In the future, the INDUS compact Sets will be equipped with a steel cable and an additional pair of cable cores instead of just a simple steel cable.

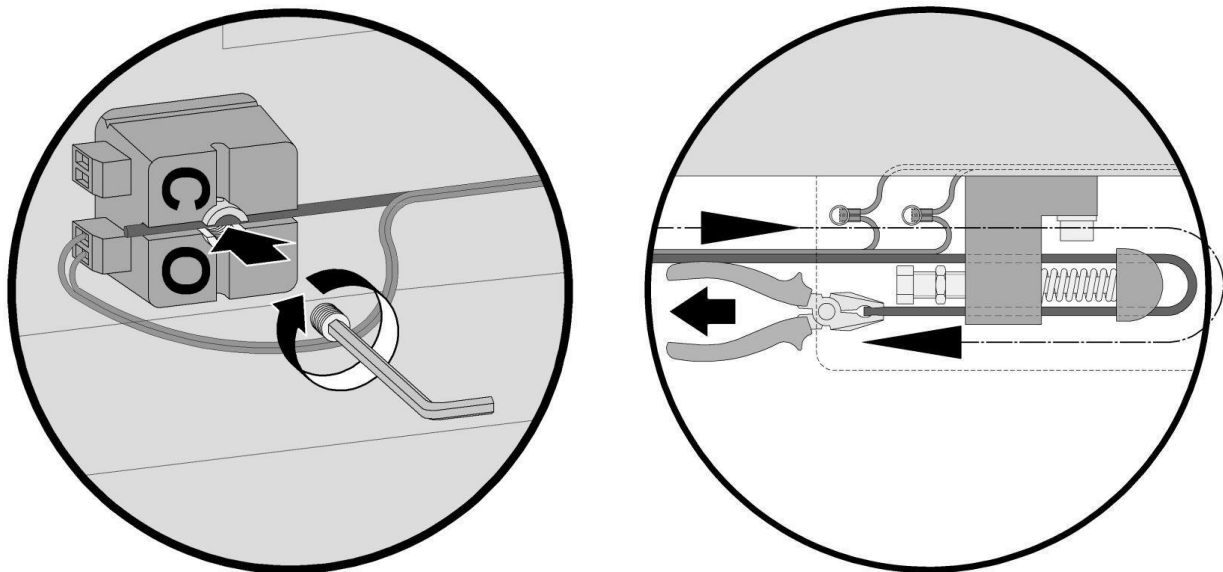
So far, the cable of the contact edge (OPEN/CLOSE) had to be installed along the gates' entire length to connect it to the travelling coil core (SPK 54).

The new steel cable with the additional pair of cable cores allows for the contact edge (OPEN/CLOSE) to be connected directly to the travelling coil core with the help of two plug-type connectors at the clamping unit.

As usual, the steel cable is to be clamped between the travelling coil core (SPK 54) and the clamping unit. Strip back the insulation at every end of the steel cable. At the travelling coil core the cable cores are put into the plug terminals OPEN/CLOSE. The cables of the contact edge are to be put into the other two plug terminals.

At the clamping unit, put one cable core into one opening of each of the plug-type connectors. The other openings in each of the plug-type connectors are meant for the cables of the contact edge.
